TPB Ref.: A/YL-PS/776

**Temporary Public Vehicle Park for Private Car for a Period of 3 Years
at Lots 387 S.C ss.3 RP (Part), 387 S.C ss.4, 387 S.C ss.5, 387 S.C ss.6
(Part), 387 S.C ss.7 (Part) & 387 S.C RP in D.D. 122, Sheung Cheung
Wai, Ping Shan, Yuen Long, New Territories**

Response to Comments

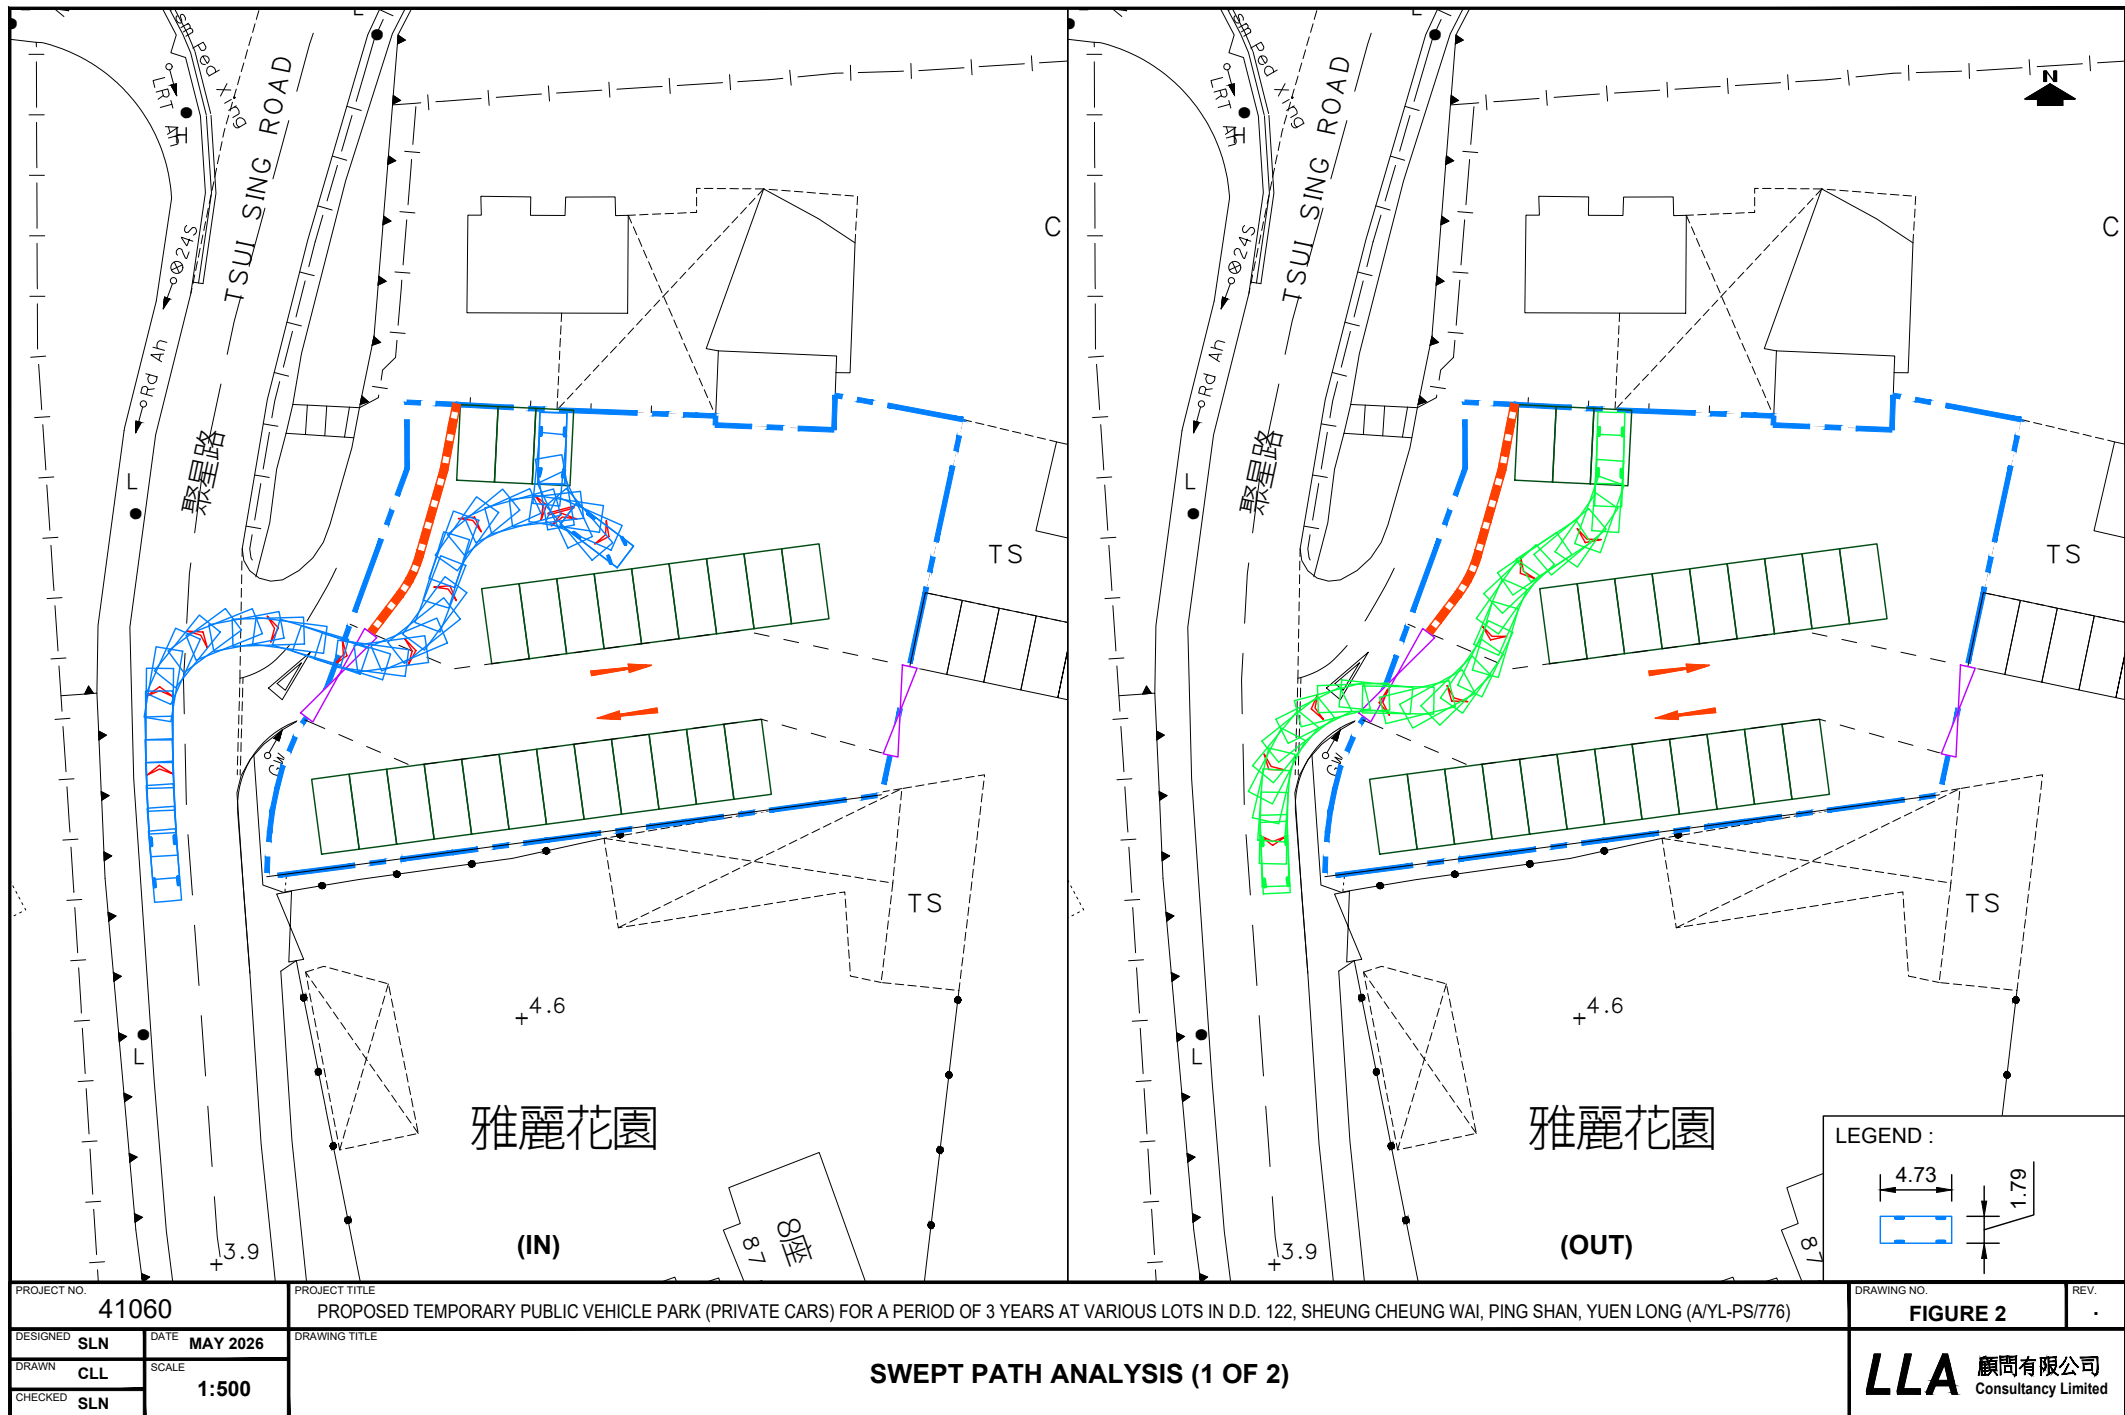
2. Please provide swept path analysis for critical locations, e.g. turning points and vehicular access to Tsui Sing Road, etc. to demonstrate smooth maneuvering for vehicles.	On site observation revealed that the existing car parking layout is not desirable. The traffic layout is modified for provision of 25 nos. of car parking space and a minimum aisle width of 6.0m can be provided. Please refer to Figure 1 for the updated layout and the swept path analysis are provided in Figure 2 and 3 .

3. Please provide photos of the proposed ingress/egress and man-gate,	At present, there is no man-gate provided. Please refer to the photo in Figure 1 showing the existing ingress/egress of the Site. The proposed layout will provide an ingress/egress of 7.0m and the Site will be fenced off by barriers (or other equivalent measures) for better access control.

4. Please indicate the width of aisles. According to TPDM, the desirable aisle width shall be 6m. Justifications with swept path analysis shall be provided if the requirements could not be fulfilled.	The traffic layout is updated and a minimum aisle width of 6.0m can be provided.
